PLANNED UNIT DEVELOPMENT, PLANNING APPROVAL &

SIDEWALK WAIVER STAFF REPORT Date: January 3, 2008

DEVELOPMENT NAME Moffett Road Assembly of God

LOCATION 6159 Moffett Road

SITE PLAN

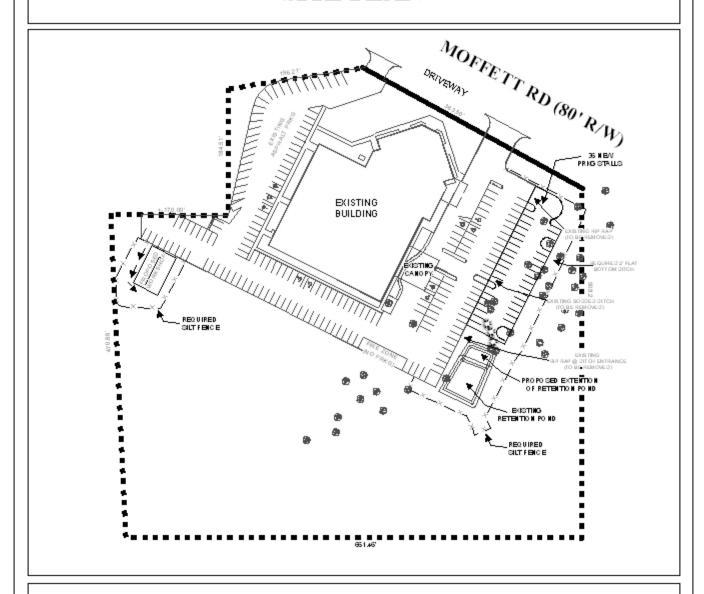
As illustrated on the site plan the existing sanctuary has seating for 670, and provides 182 parking spaces on the premises. The Zoning Ordinance requires 1 parking space per 4 seats in the sanctuary; therefore, the site exceeds the minimum parking requirements of

the Ordinance. Additional parking spaces are depicted on the site plan, adjacent and to the east of the existing parking. Additional parking to exceed the minimum requirements in the proposed parking area may be beneficial for the church.

The existing parking area does meet the minimum access and maneuvering requirements of the Zoning Ordinance, and the access way to the maintenance storage shed proposed behind the church would meet the minimum accessibility requirements of the Zoning Ordinance.

The project areas should be brought into compliance with the Zoning Ordinance in terms of trees, landscaping and residential adjacency buffering. Thus, frontage trees should be provided along Moffett Road (and are not depicted on the site plan), and perimeter trees and a wooden privacy fence should be provided where the parking / storage shed area abuts residentially developed properties. It should be noted that the wooden privacy fence should not exceed 3-feet in height where the fence is within 25-feet of a street right-of-way.

The proposed parking area should be designed so that vehicles that park do not over hang the concrete wheel stops to the extent that any existing or provided privacy fencing is damaged.

The new construction for parking and the maintenance/storage building may result in a need for storm water detention. If a storm water detention pond significantly changes the PUD and Planning Approval site plans, new plans and applications should be submitted to depict the required detention.

As Engineering Department states there are significant topographic constraints (roadside ditch) that would preclude the construction of a sidewalk at this location.

- 1) the construction be limited to the submitted and approved site plan;
- 2) revision of the site plan to depict the buffer requirements of the Ordinance where the site abuts residential uses of the site;
- 3) revision of the site plan to depict sidewalks along Moffett Road (unless waiver is approved);
- 4) revision of the site plan to depict any dumpster storage facility, in compliance with Section 64-4.D.9. of the Zoning Ordinance;

- 5) placement of a note on the site plan stating that on-site lighting must fully comply with Sections 64-4.A.2. and 64-6.A.3.c. of the Zoning Ordinance;
- 6) provision of a revised site plan to the Planning Section of Urban Development prior to the issuance of any permits; and
- 7) full compliance with all other municipal codes and ordinances.
